BOARD ACTION REPORT – APPEALABLE ITEM

Project Name: Bahia Delray
Project Location: 1001 Crystal Way
Request: Class IV Site Plan Modification consisting of the site plan, architectural elevations, and landscape plan.

Board: Site Plan Review and Appearance Board

---STAFF REPORT---

IMPACT RESISTANT, WHITE ALUMINUM FRAME WINDOWS
- 5

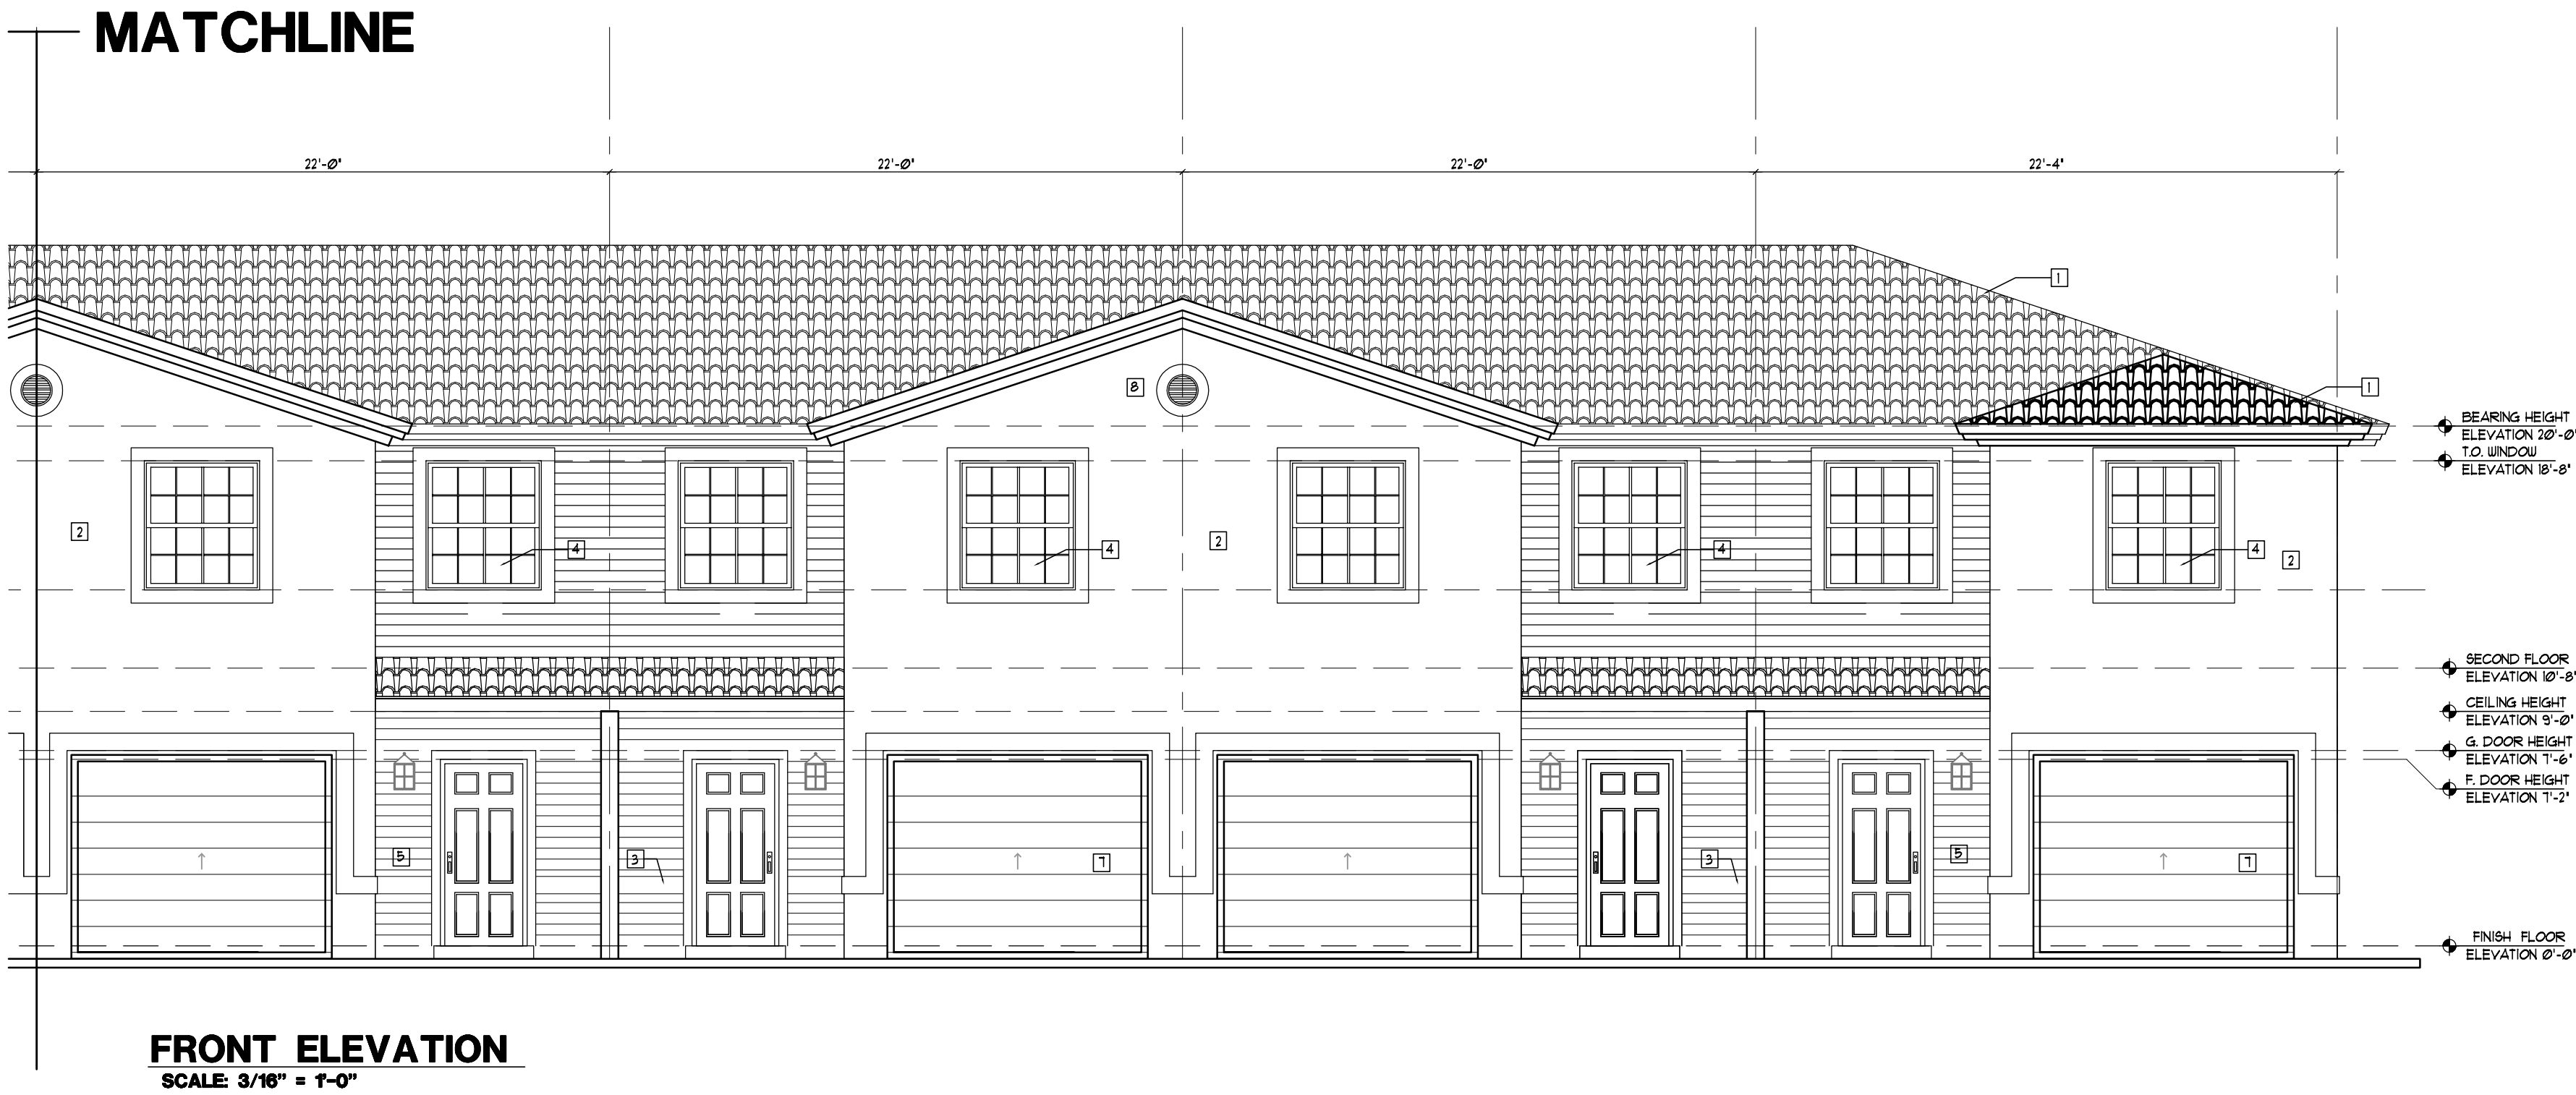
1. That revised elevations for Building #3 be provided which mirror the presently proposed elevations, to preserve Tree #197; and,
2. That the color scheme be revised to be consist with the existing development, including the roof tile color.

The proposed elevations consist of a lightly textured stucco with cementitious siding on the inset portion of the front elevation. The roof and entry overhangs at both the front and rear are finished with a beige "S" tile. The color scheme is a beige siding and puddy stucco with brown trim, accents, and shutters, light blue doors. The windows have white frames and muntins.

In general the proposal is in good taste and design, although it is simpler than the more decorative buildings that exist within the development. This differentiation may be determined to illustrate the different building and unit type, as also exemplified by the garage components within the new buildings. However, additional details and a revised color scheme, inclusive of the roof tile, should be provided to unify the new buildings with the existing buildings and/or the existing building painted to be consistent with the new buildings. The existing buildings are each painted differently in a pastel color, and are finished with a white flat, cement tile roof.

The proposed elevations can be supported with positive findings subject to the revision of the color scheme to appropriately compliment or match the existing buildings, including the roof tile color. This recommended revision will assist in providing harmony with the existing development while not causing depreciation to the development.

Sheet Description
TREE
DISPOSITION
PLAN

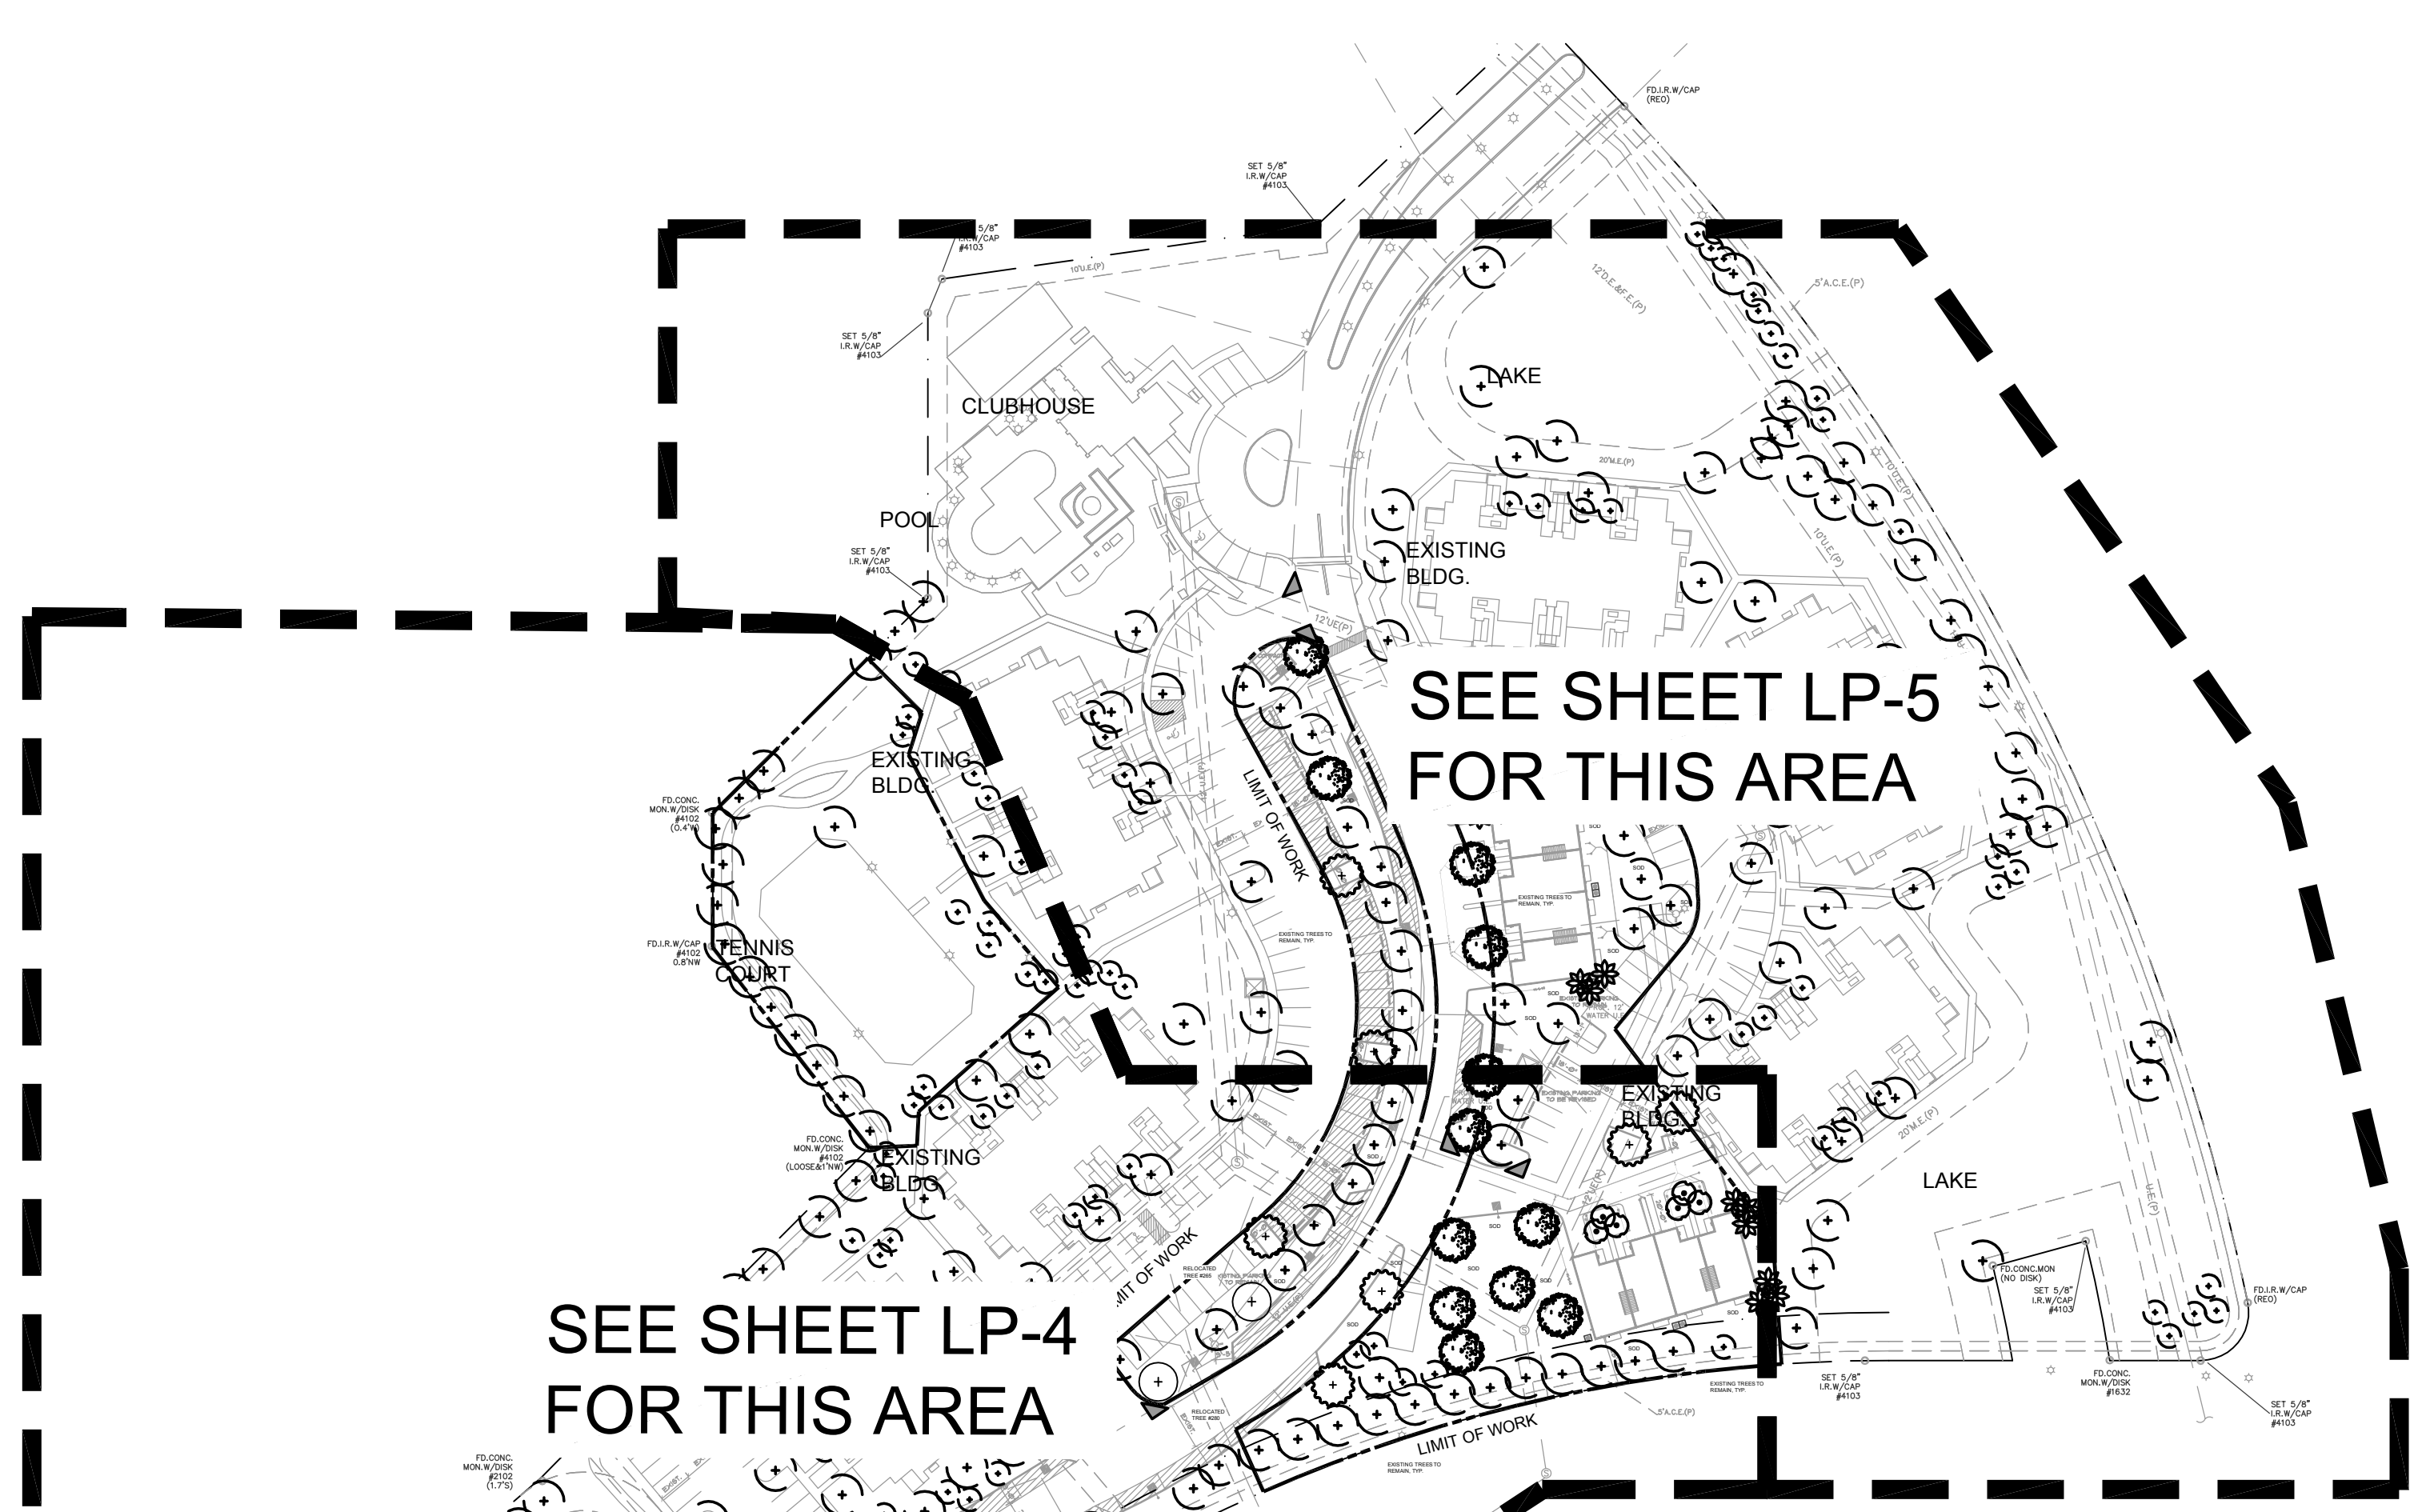
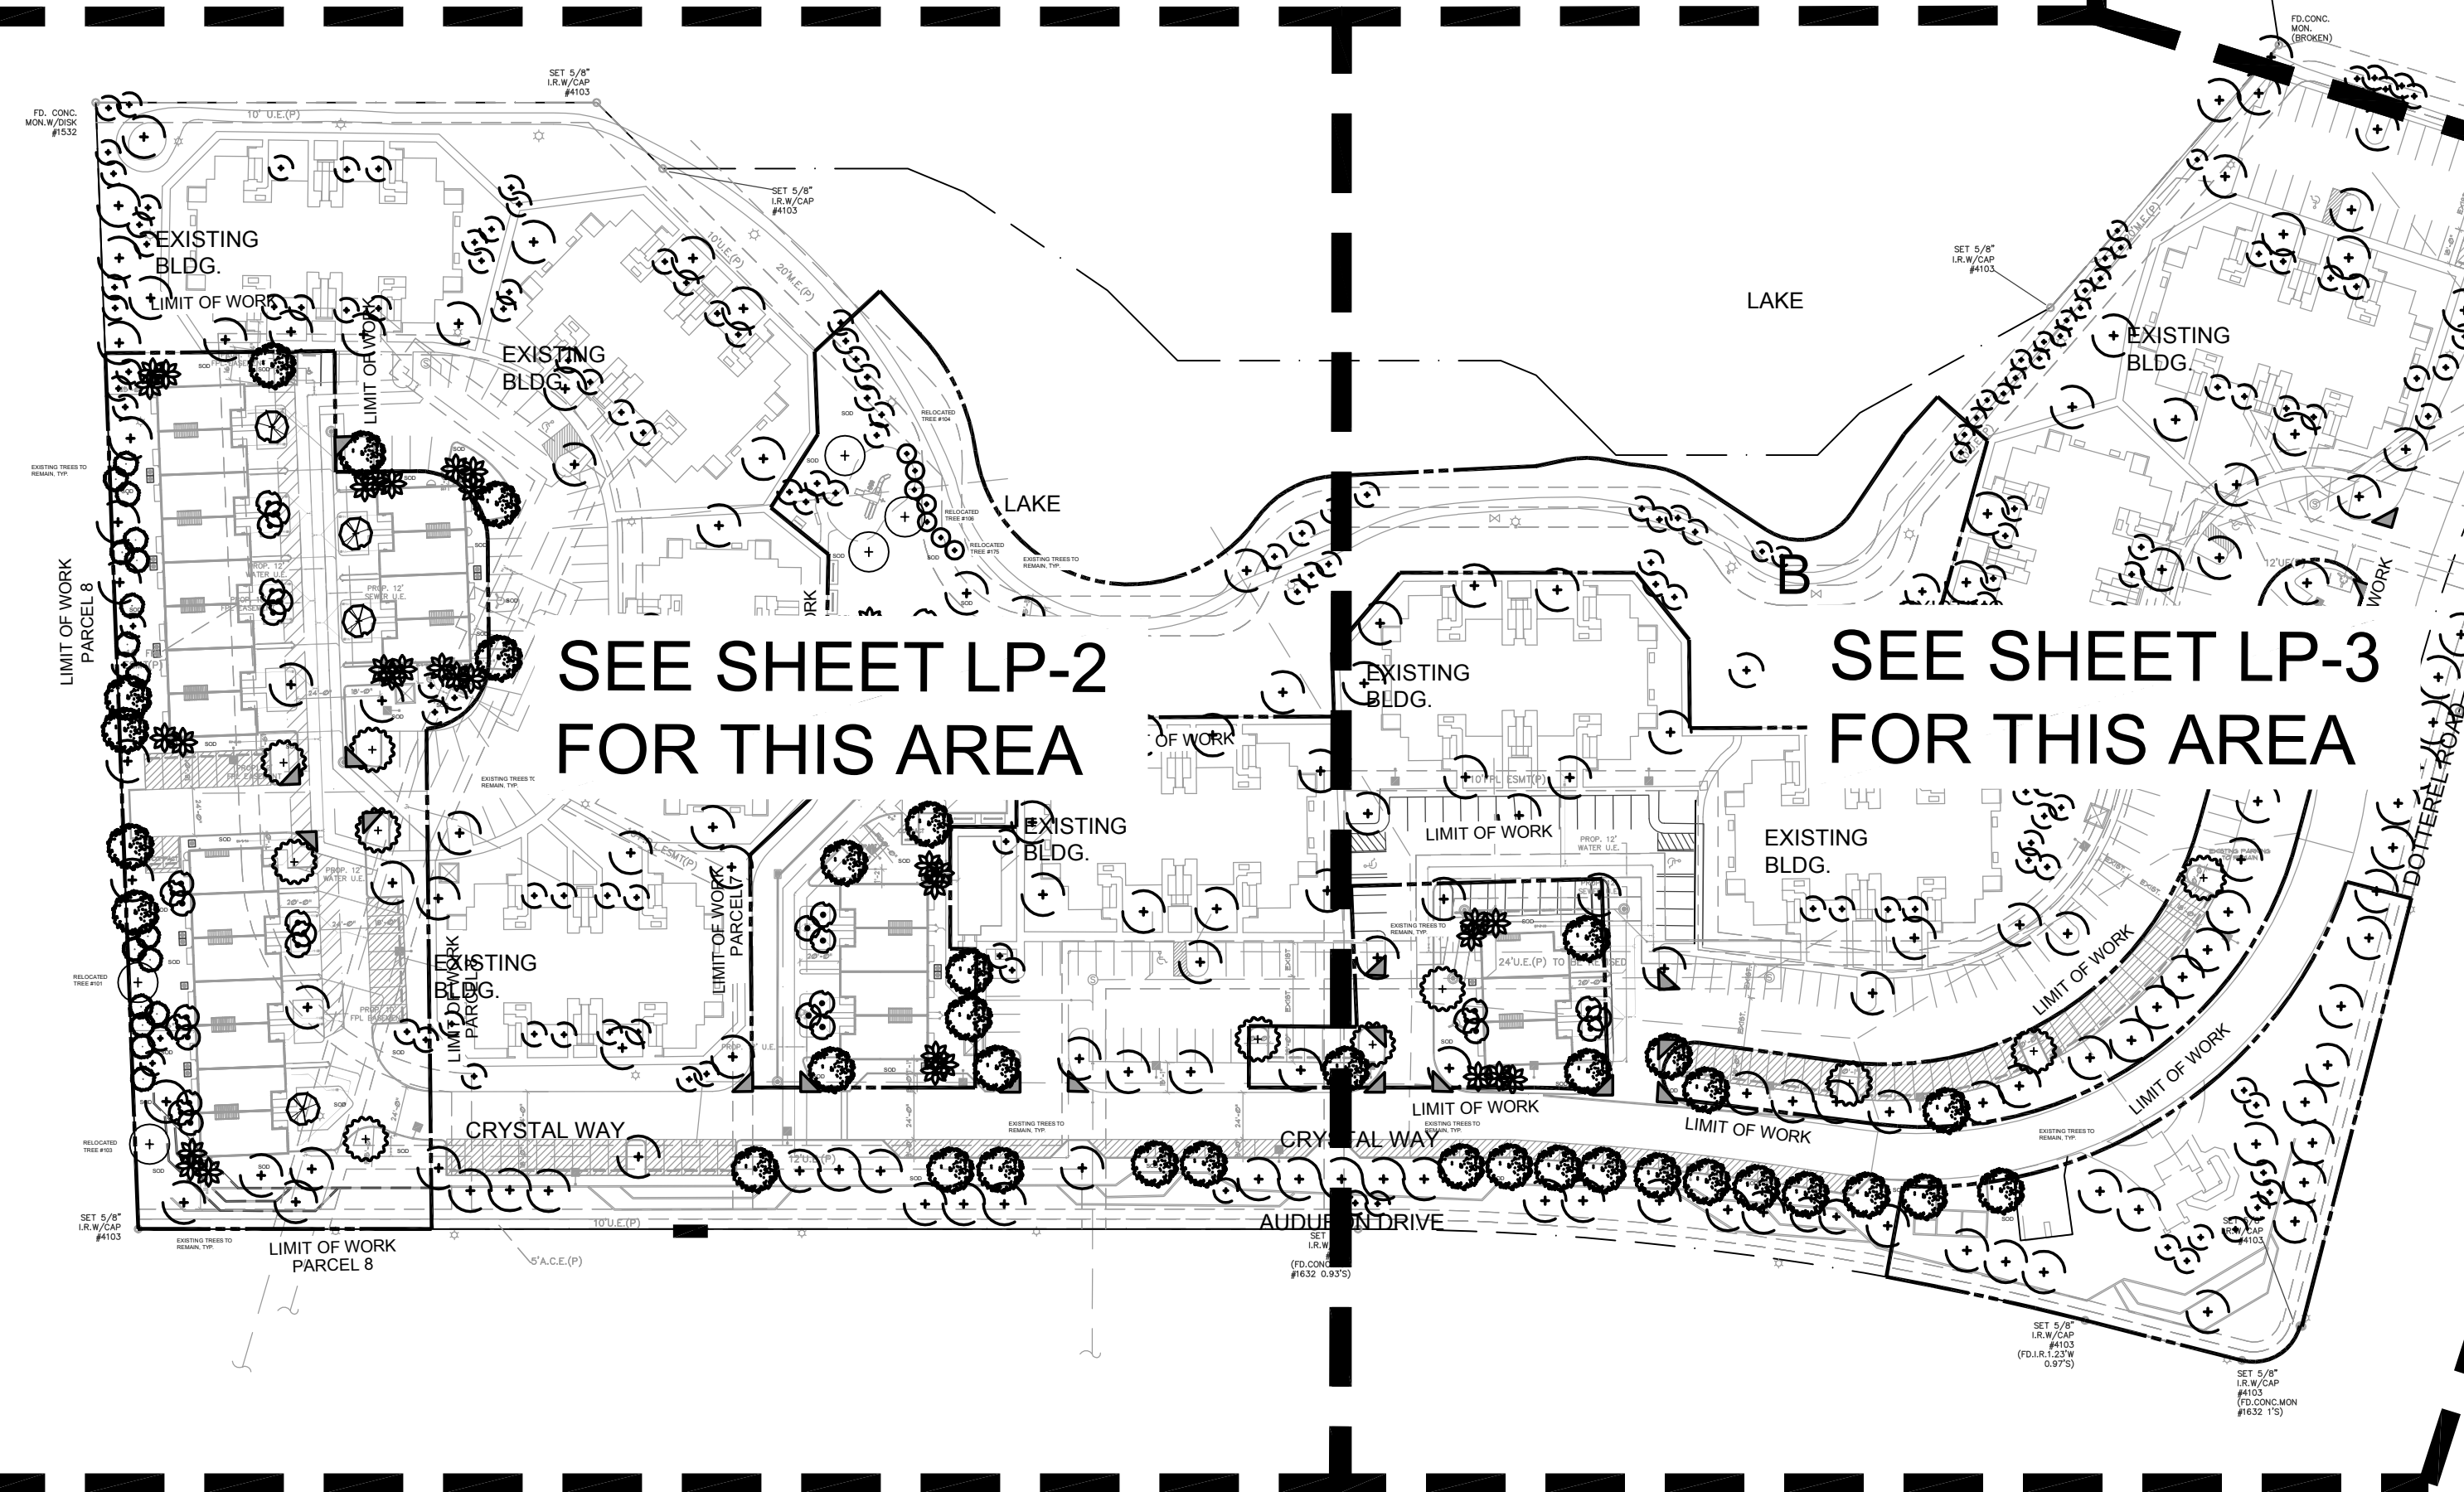
Landscape Plan: Approve subject to the condition that the plan be revised in accordance with the site plan revisions associated with the preservation of Tree #194 and Tree #197.

The Landscape Architect's report (attached) notes that Tree #197, a 22" caliber Mahogany, may also be saved in location, as opposed to being relocated, if "we can mirror Building #3 north to south" then this tree could be preserved in place. It appears that this is possible, but will require revisions to the elevations, site, and landscape plans. Staff is supportive of this revision, and recommends that it be included as a condition of approval.
